NAVFAC SPECIFICATION 10-5314

**AMENDMENT NO. 0001**

14. DESCRIPTION OF AMENDMENT/MODIFIC where feasible.)	CATION (Organized	by UCF section headings, including solic	itat	ion/contract subject r	natter			
P136 BACHELOR ENLISTED QUARTERS, MCAS	S CHERRY POINT, NO	ORTH CAROLINA						
THE PURPOSE OF THIS AMENDMENT IS TO RESPOND TO RFIS								
RECEIPT OF PROPOSALS REWAIN SEPTEMBER 30, 2010 @ 2:00PM								
ALL REQUESTS FOR INFORMATION (RFIs) MUTHE PROPOSAL DUE DATE	ST BE SUBMITTED VI	IA EMAIL TO michael.brice@navy.mil N	ЮL	ATER THAN 10 DAY	'S BEFO	ORE		
Except as provided herein, all terms and conditions of the do	cument referenced in Items	) A or 10 A as heretofore changed ramping unabou	ngad	and in full force and effect				
15A. NAME AND TITLE OF SIGNER (Type or		16A. NAME AND TITLE OF CO	_			or print)

E-7

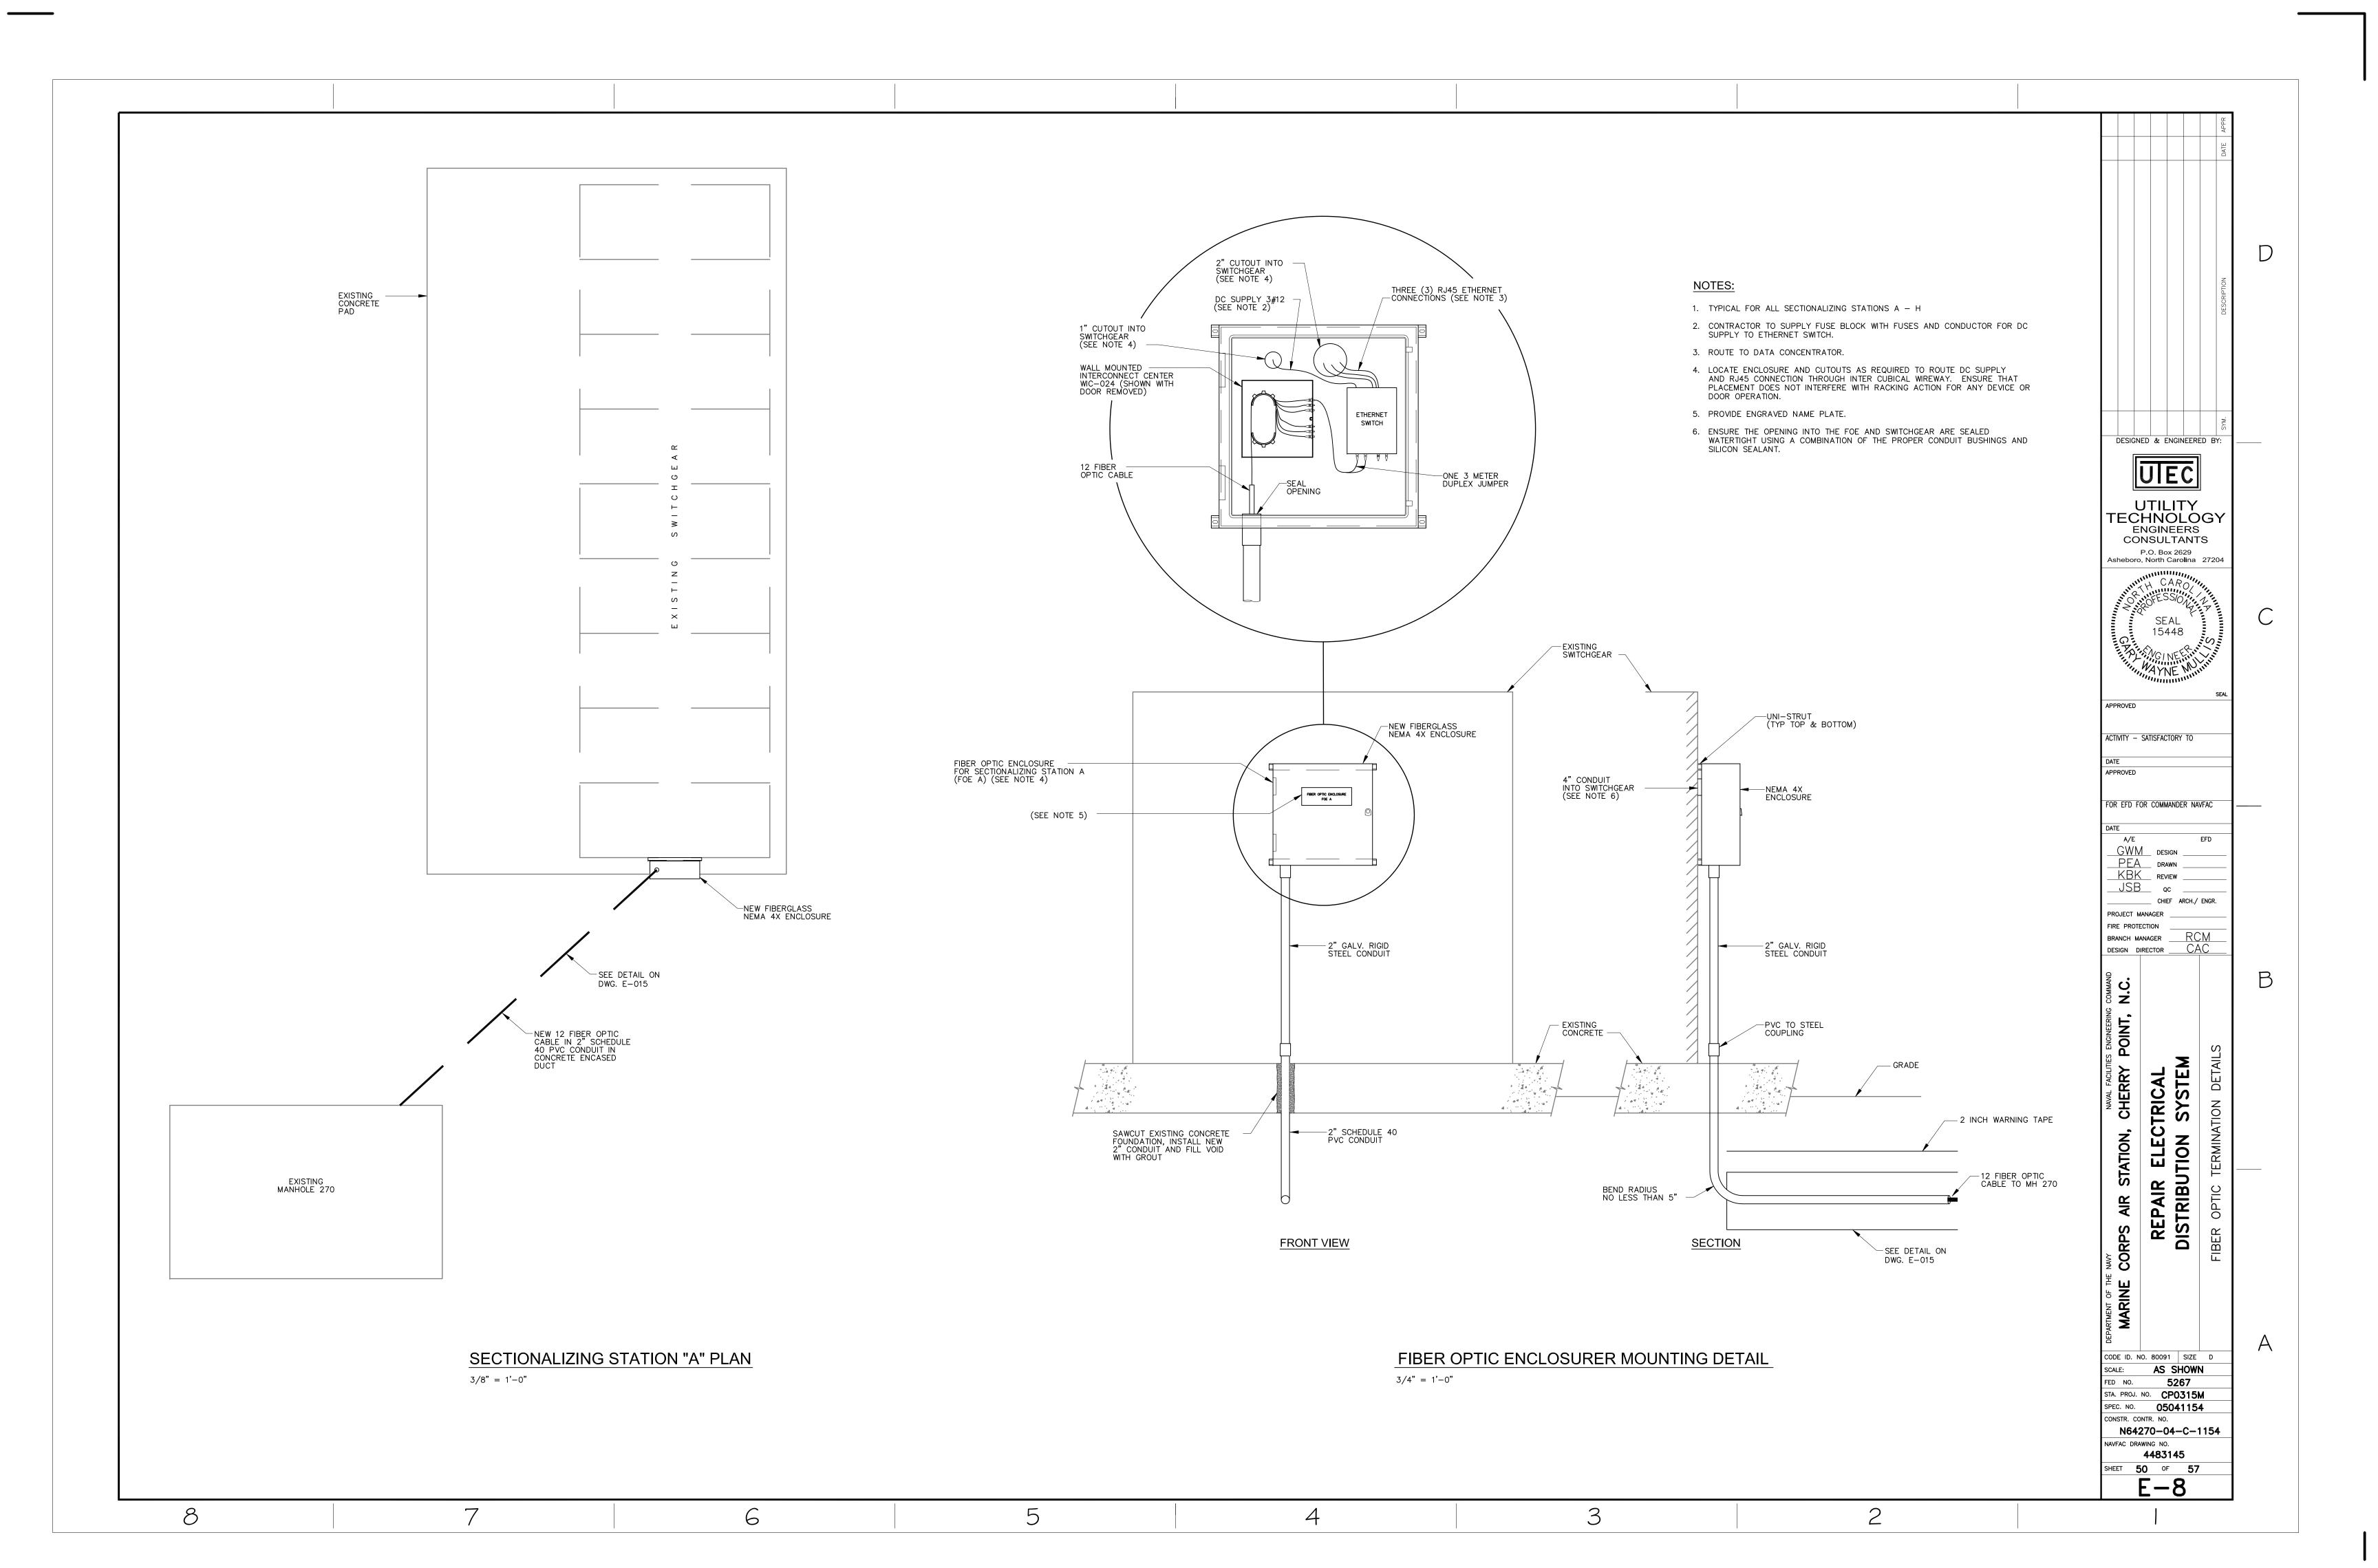
<u>Question:</u> Please provide a legend for Drawing E-2. What is the difference between dashed and solid lines? Please identify the locations of Sectionalizing Station A and manhole MH18.

<u>Response:</u> E-2 was provided only as a reference sketch of A-1, A-2, A-3, and A-4 feeders. The dashed/solid lines indicate the route of those existing feeders. Sectionalizing Station A is the yellow block on C Street between 4th and 5th Ave, labeled, "A". MH18 is located between D and E streets in the middle of the existing parking lot.
